State Concerns

On the Rocky Mountain Arsenal Offpost Proposed Plan

Colorado
Department
of Health

April 1993

Rocky Mountain Arsenal and Offpost Study Areas

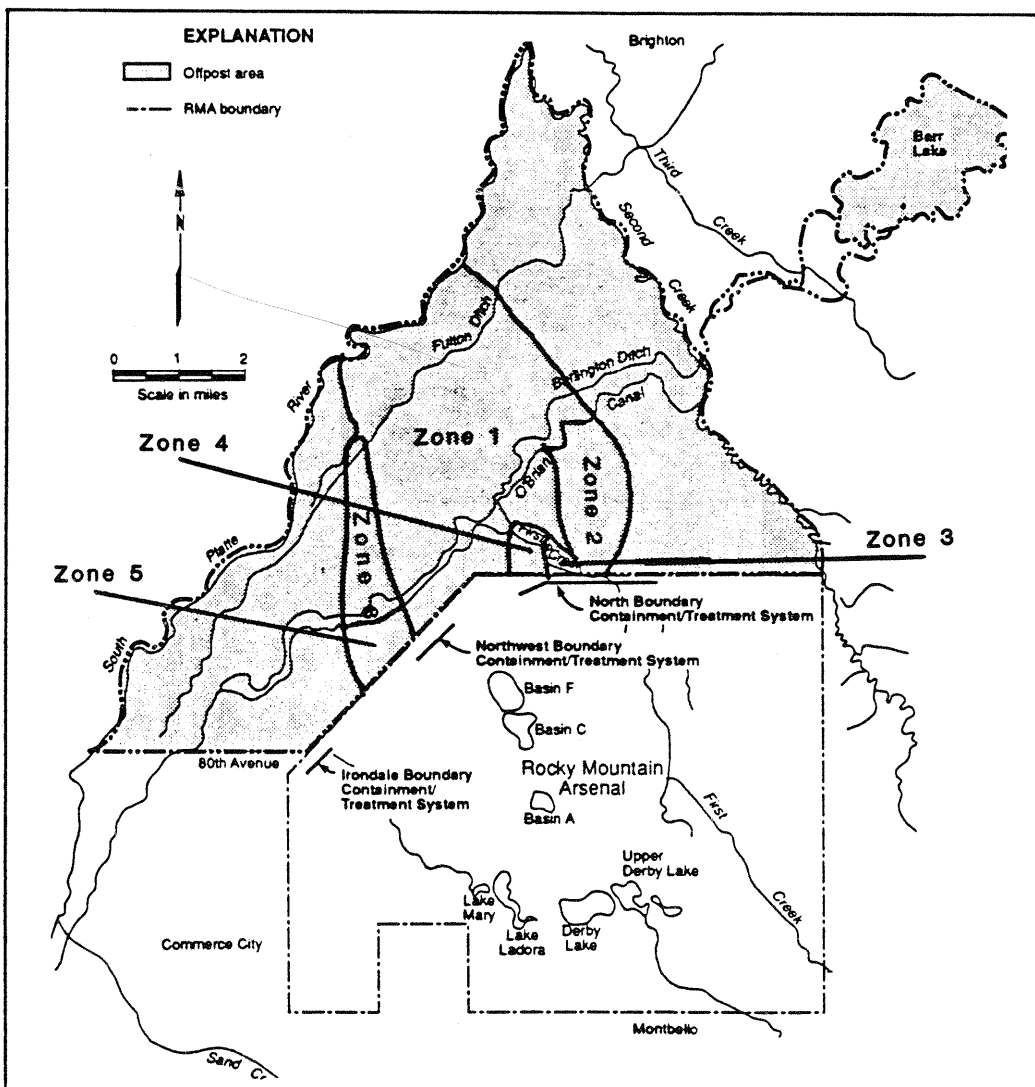
Zones 2, 3 and 4, as depicted on the illustration, are the most highly contaminated areas of the offpost study area. Contamination has been found in ground water, soil, and surface water. At current concentrations such contamination, according to the Army's studies, could pose excess cancer risks of approximately 3 in 10,000. The Army states that potential risks as high as 1 in 2,000 are acceptable. However, the state believes that federal law requires Superfund cleanups to aim for an excess cancer risk of not more than 1 in 1,000,000, unless that number cannot be achieved.

Federal law states that hazard indices reflecting non-cancer risk should not exceed one. The Proposed Plan indicates that the hazard index exceeds one in Zones 2, 3 and 4 and a portion of Zone 1. This means that people exposed to existing contamination in those areas could suffer adverse health effects other than cancer, ranging from short-term effects such as eye and skin irritation to long-term effects such as asthma, liver or kidney damage. The state believes that the risk should be reduced at least to the hazard index of one.

Zones 3 and 4 are owned by Shell Oil Company; Zone 2 is mostly privately owned. The Proposed Plan does not include active cleanup of soil in these three zones. In addition, ground water contamination will likely remain there for decades while it is gradually flushed by water treated at the North Boundary System. The Proposed Plan does not provide any mechanism for preventing people from drinking ground water while it is being cleaned up. Nor is there a commitment to provide access and use controls (like deed and well restrictions) to prevent exposure to water or soils. Therefore, the state would

like the Army to evaluate active remediation of the soil and at the very least initiate measures which would prevent exposures to ground water until it is cleaned up.
